ADDENDUM #1 04/01/2024
REVISED SHEETS: TITLE, D11, D12, D14, P1, P2, P4
REVISION #1 06/18/2024
REVISED SHEETS: TITLE, D8A(ADDED), P1-P4, P6, U5, U6, U10, W5, W6
REVISION #2 07/17/2024
REVISED SHEETS: TITLE, D8B(ADDED), D11, P1-P2, P5-P6, W3, MN1-MN2
REVISION #3 07/26/2024
REVISED SHEETS: TITLE, U2-U4, U7, U9, U11-U13, W2-W4, E1-E10
REVISION #4 08/15/2024
REVISED SHEETS: TITLE, D11, D12, P1, P2, U2-U4, U9, U10, U11, PM8, X3, X4
REVISION #5 08/26/2024
REVISED SHEETS: TITLE, U4, U9-U11, W4
REVISION #6 09/10/2024
EVISED SHEETS: TITLE, P5, U4, U8, U9, PM1-PM8

E. WILSON ST. AND E. DOTY ST. RECONSTRUCTION

CITY PROJECT NO. 11543
CONTRACT NO. 8735

PM-5

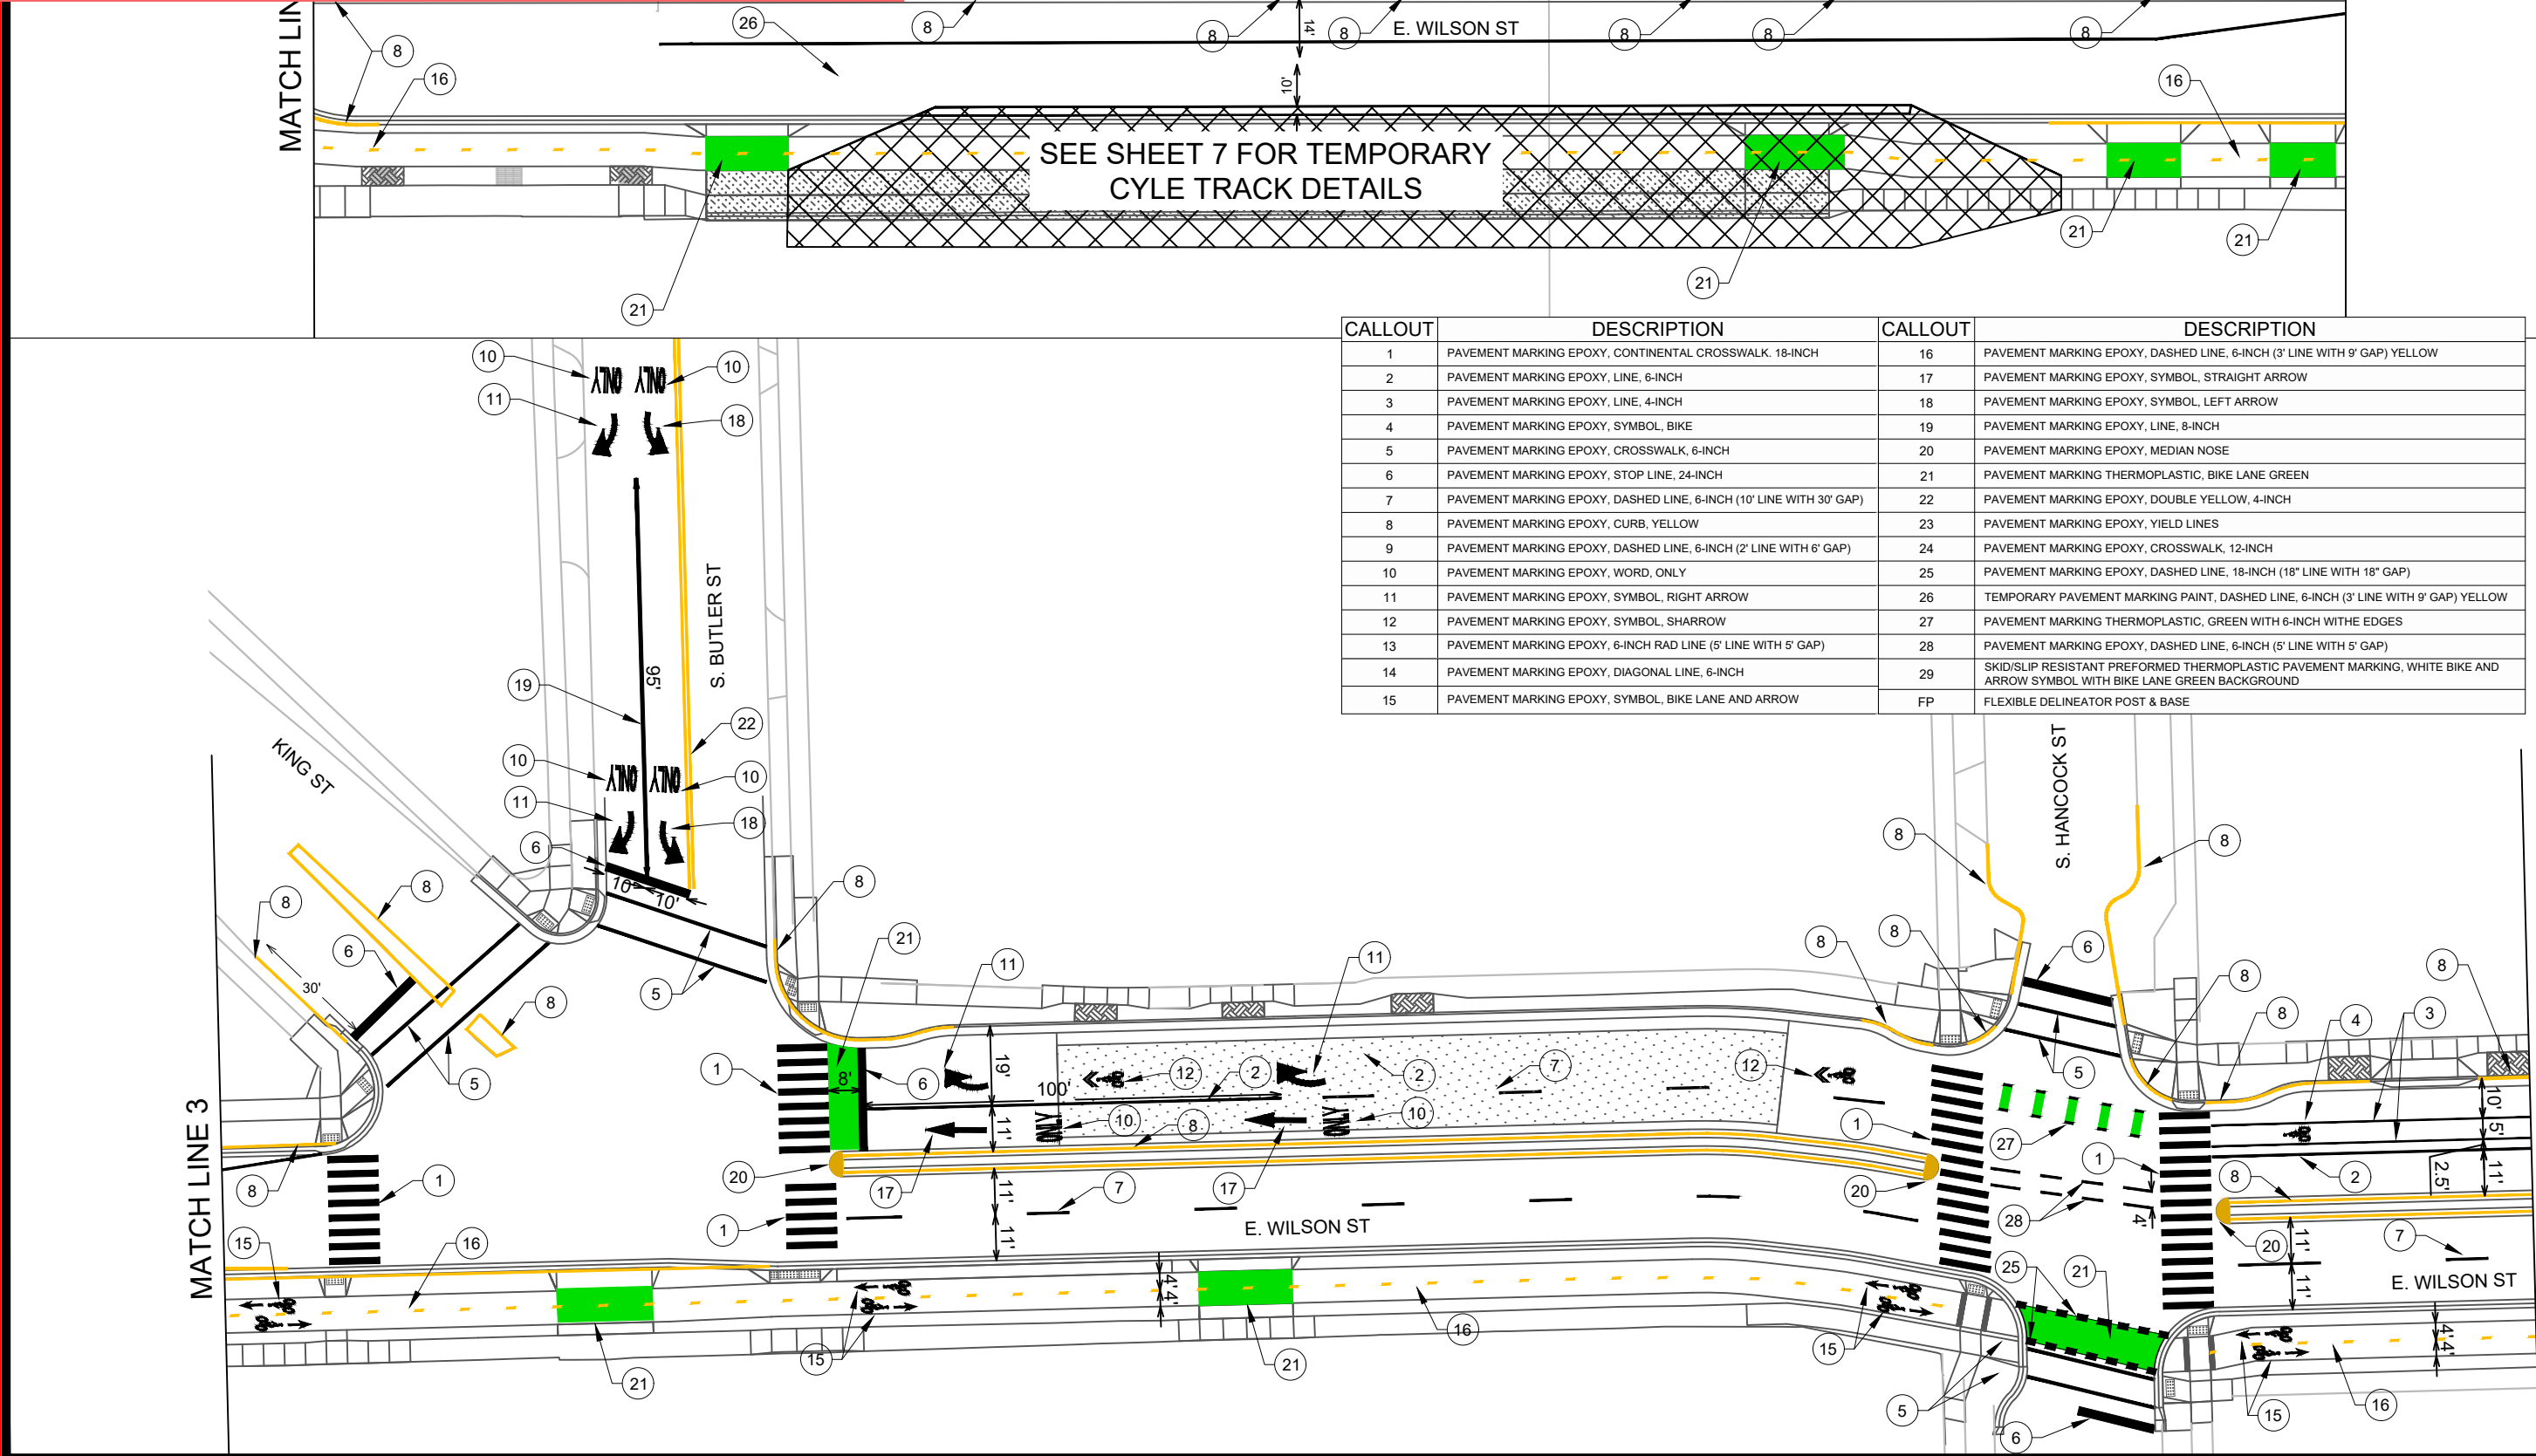
- Green bike box limits changed to match new curb.
- Additional yellow curb paint added.
- Yellow curb paint to be installed after City of Madison Parking Utility installs their pavement markings for the curb side parking stalls.
- Contact Lukas Collins at 608-261-9625 prior to yellow curb installation.
- Limits of yellow curb paint to be determined by Traffic Engineering.

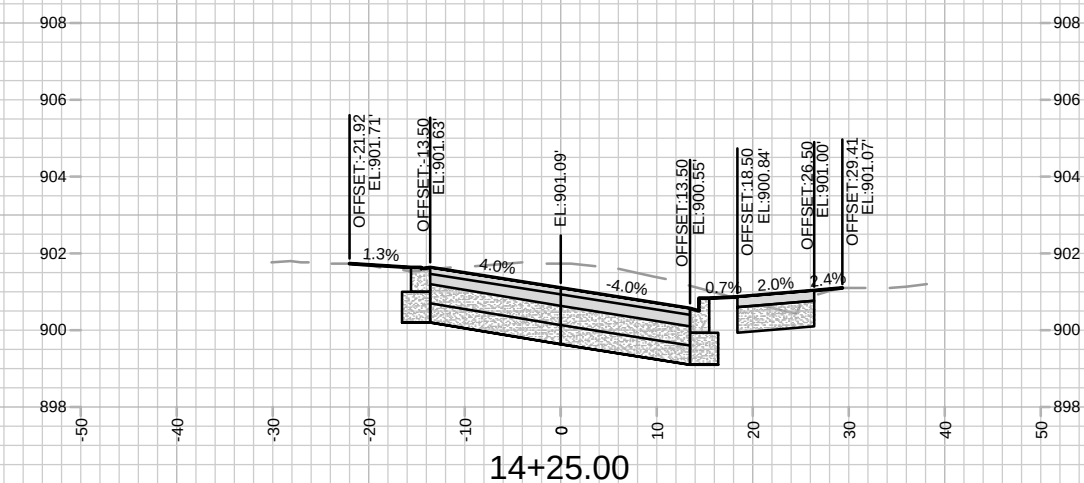
1. ADJUSTED CURB GRADES ALONG SOUTH SIDE STARTING AT STA 14+71. THIS CHANGED CROSS SECTION AT STA 14+75.

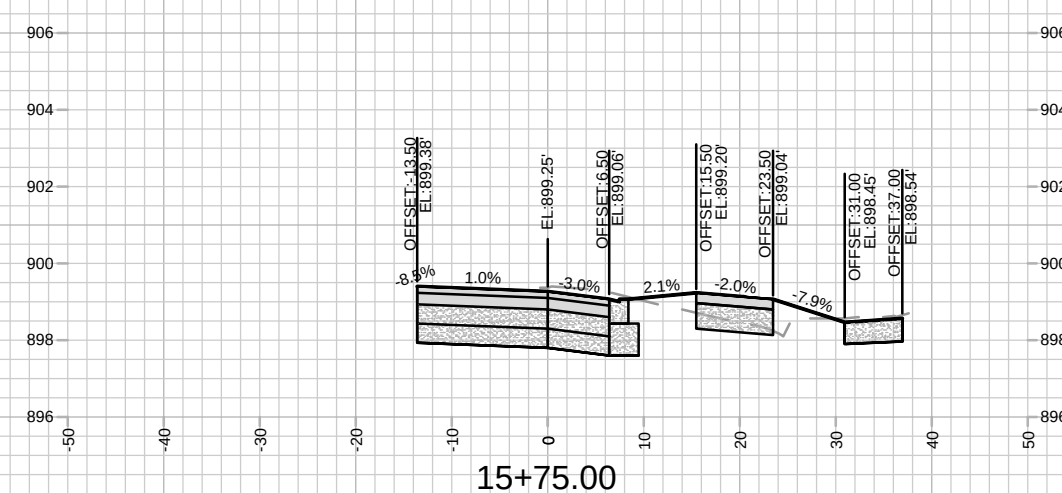
1. ADJUSTED CURB GRADES ALONG SOUTH SIDE STARTING AT STA 14+71. THIS CHANGED CROSS SECTION AT STA 15+00.
